# ROCKY FLATS SITE REGULATORY CONTACT RECORD 2020-01

**Purpose:** Soil Disturbance Review Plan—Solar Pond Influent (SPIN) Vault Drain Line Installation

Contact Record Approval Date: November 23, 2020

Figure 1. SPIN Vault Drain Location

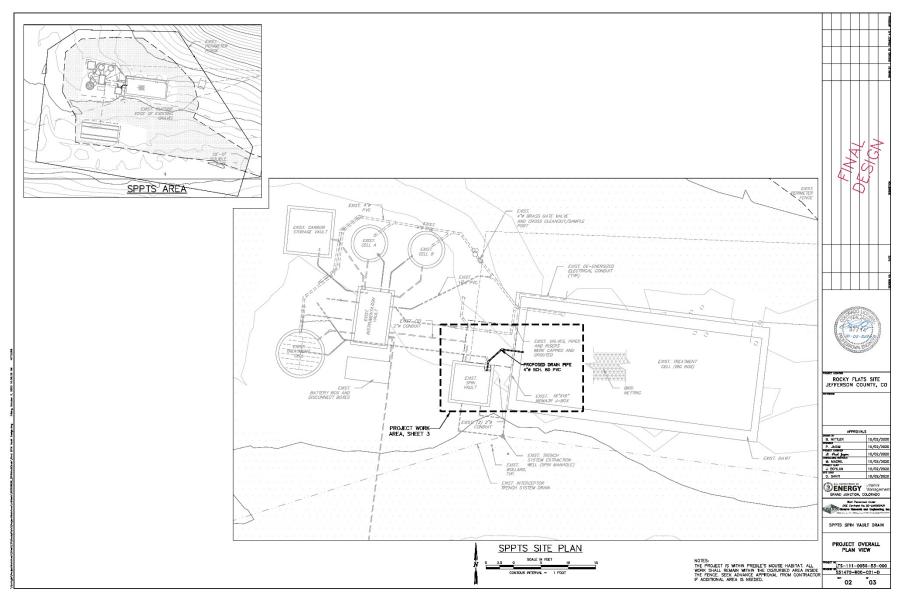
Drain line installation will be accomplished by excavating an area between the SPIN vault and the Big Box, as shown in Figure 1. The soil to be excavated during this project is imported, compacted fill placed when the additional vaults and buried plumbing in this area were installed in the 2008–2009 time frame. The excavation is anticipated not to exceed a 10 feet (ft) wide, 10 ft long, and 5 ft deep area. Efforts will be made to minimize excavated material; however, a large enough excavation will be required for personnel to safely access the underside of the SPIN vault and permit safe concrete coring operations into the side of the Big Box. The soil will be excavated using manual and/or air vacuum (air-knifing) excavation methods. If air-knife potholing is utilized to identify and protect SPPTS subsurface components, it is anticipated that activity will provide the majority of the required excavation. All excavated material will be stored on a temporary liner near the excavation and will be used to backfill the excavation to original grade or higher once the drain line installation is complete.

**Resolution:** CDPHE, after reviewing information regarding the proposed soil disturbance and excavation and after consultation with EPA, approves proposed activities described in this Contact Record. CDPHE determined that the proposed activities are not anticipated to compromise or impair the function of the remedy and are not expected to result in an unacceptable release or exposure to residual subsurface contamination. CDPHE also determined that the proposed project meets the rationale and objective of IC 2.
